ADDENDUM TO THE CONTRACT DOCUMENTS	Page Number 1	No. of Pages 10
<b>Addendum No. One(1)</b>	<b>Date Addendum Issued:</b> May 14, 2020	
<b>Issuing Office</b> Alaska State Parks, Design & Construction Section 550 West 7 <sup>th</sup> Avenue, Suite 1340 Anchorage, Alaska 99501 Phone: (907) 269-8731 Fax: (907) 269-8917	<b>Previous Addenda Issued</b> None.	
<b>Project:</b> Eagle River Nature Center Trailhead Improvements <b>Project No.:</b> 79284-1	<b>Date &amp; Hour of Quotes Due:</b> May 21, 2020 2:00 PM prevailing time

Project Name: Eagle River Nature Center Trailhead Improvements

Project Number: 79284-1

**SITE PLAN**

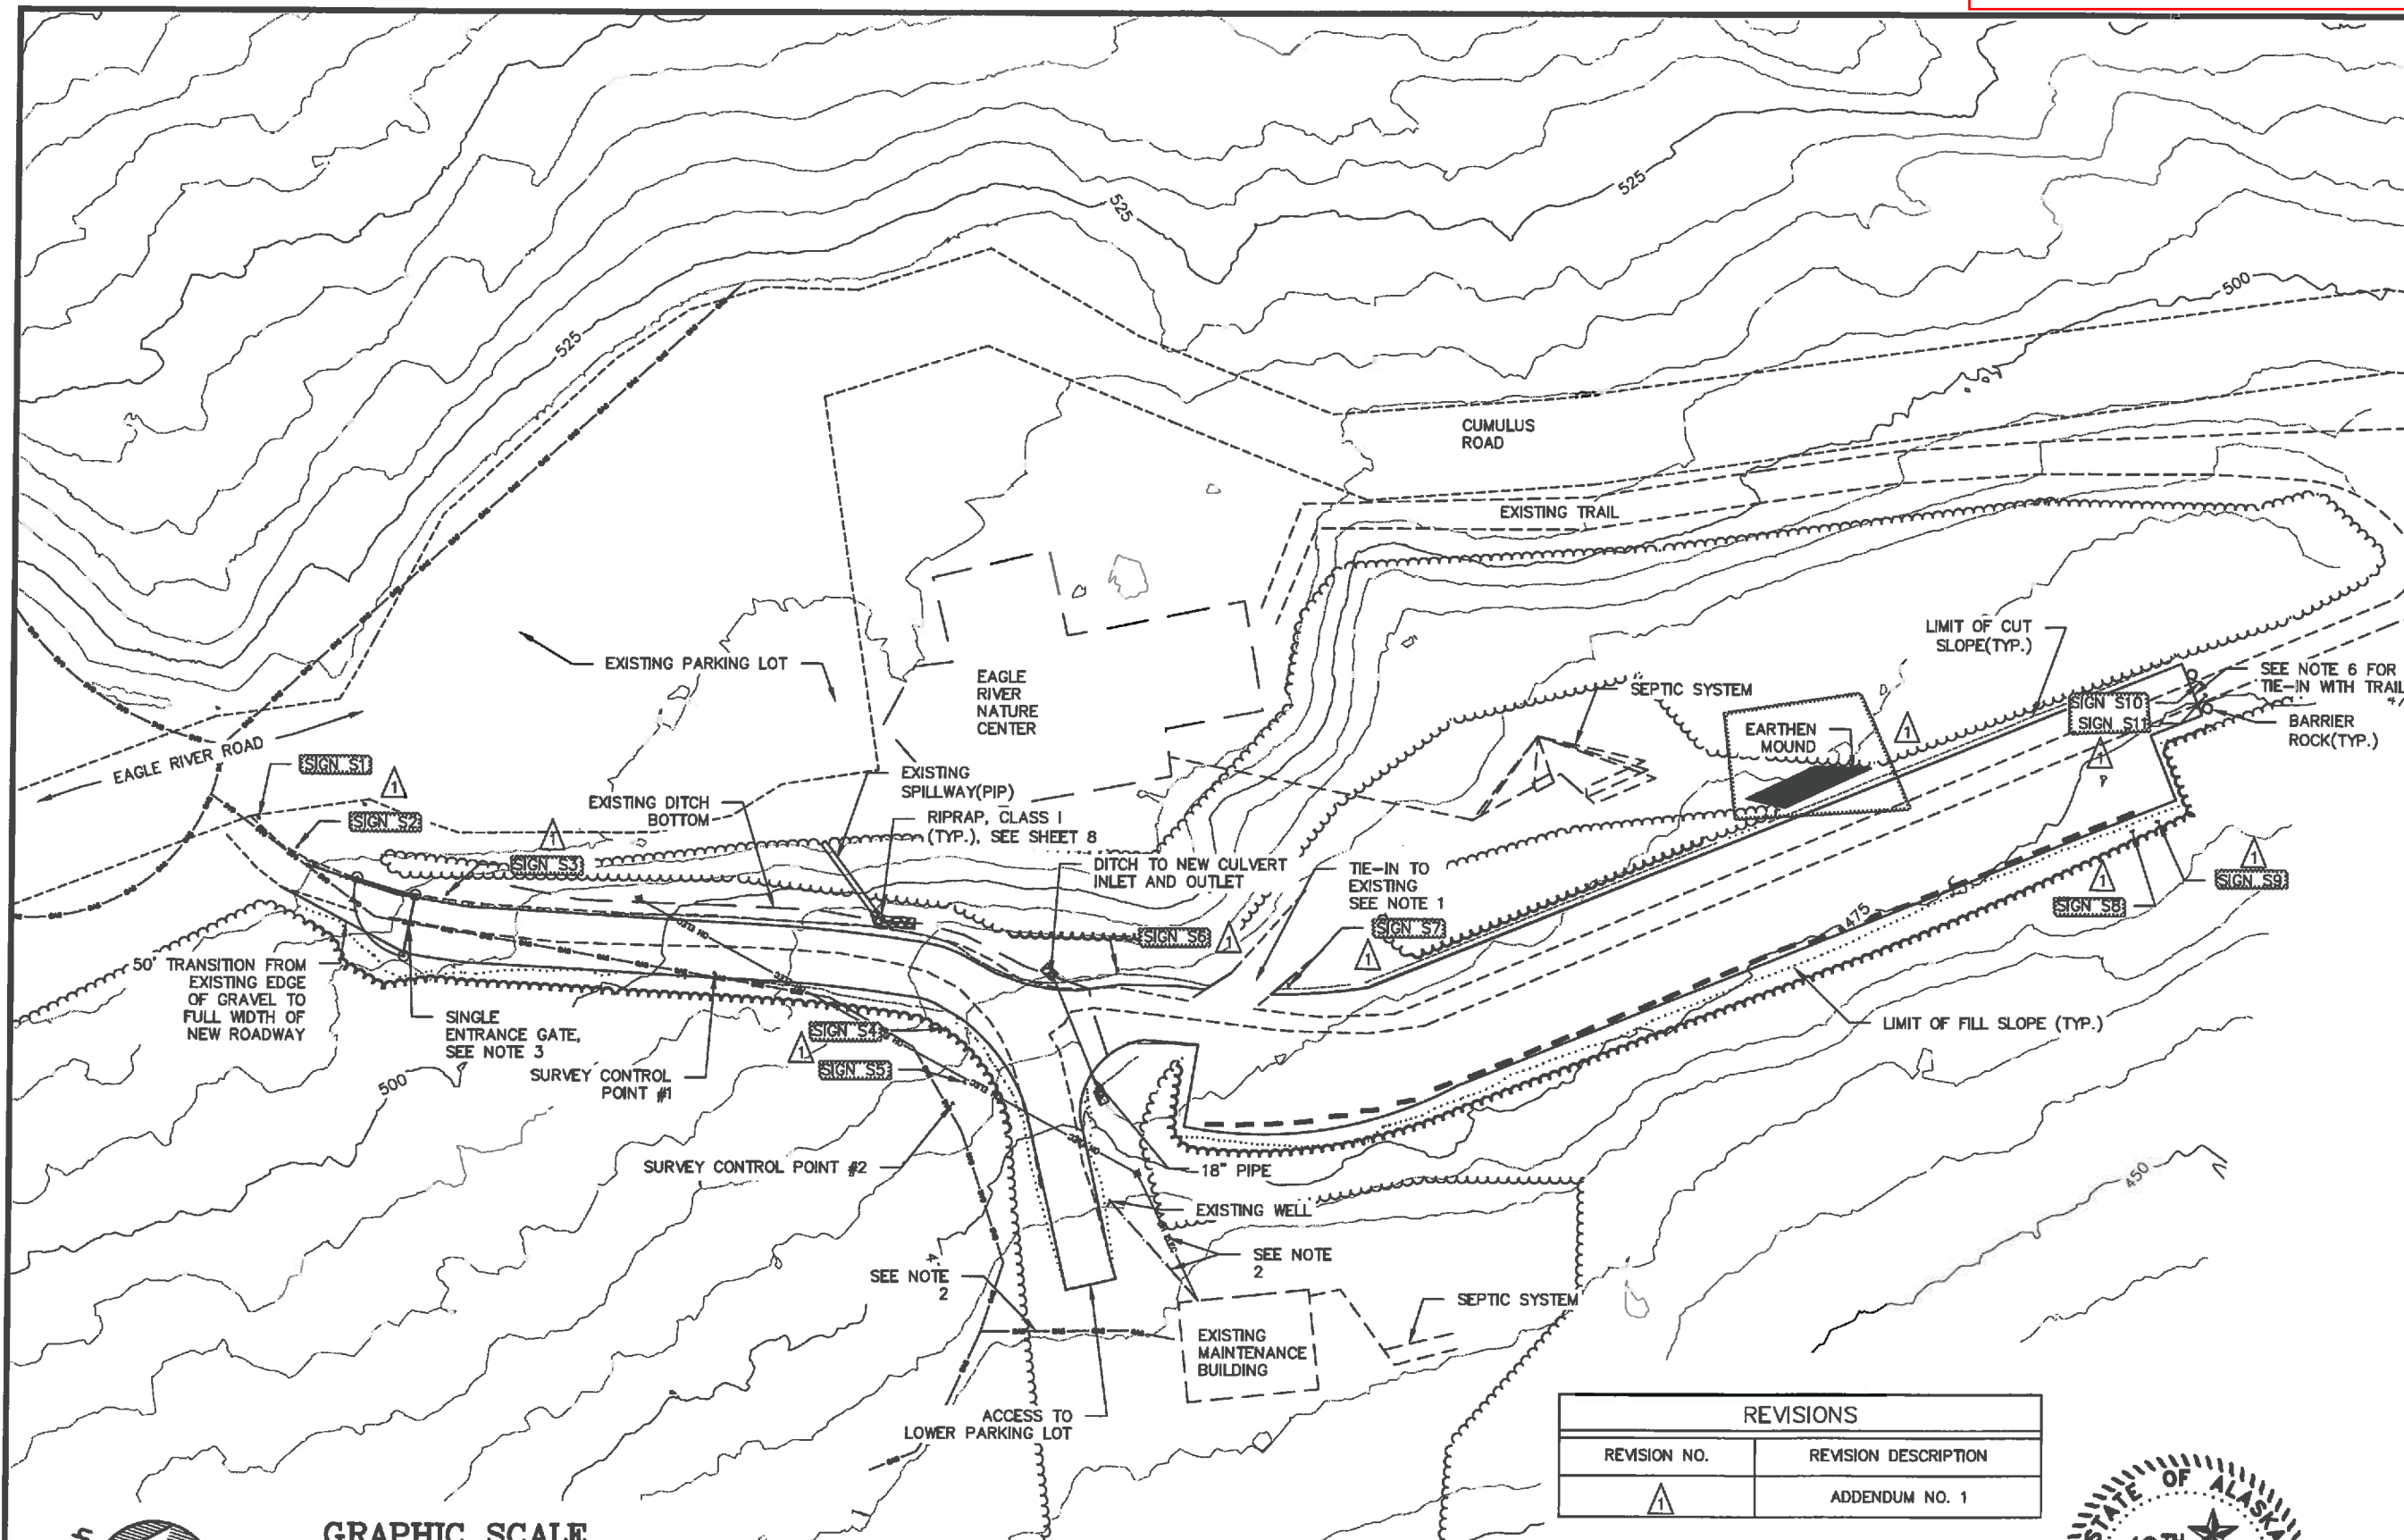
Replace Sheet 5: Site Plan, with the revised Sheet 5: Site Plan (Addendum No. 1 – Attachment B).

ESTIMATE OF QUANTITIES & SUMMARY TABLES

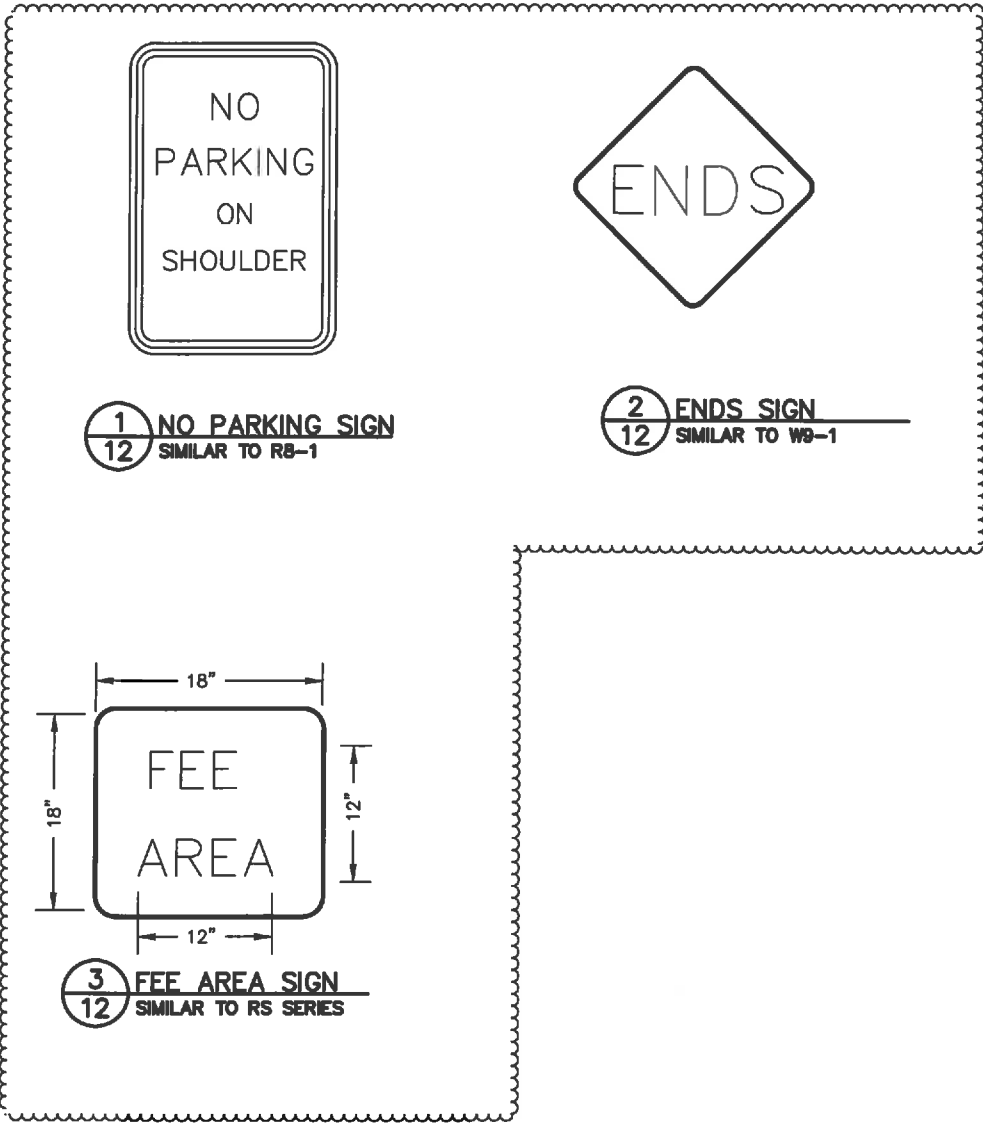
Replace Sheet 6: Estimate of Quantities and Summary Tables, with the revised Sheet 6: Estimate of Quantities and Summary Tables (Addendum No. 1 – Attachment C).
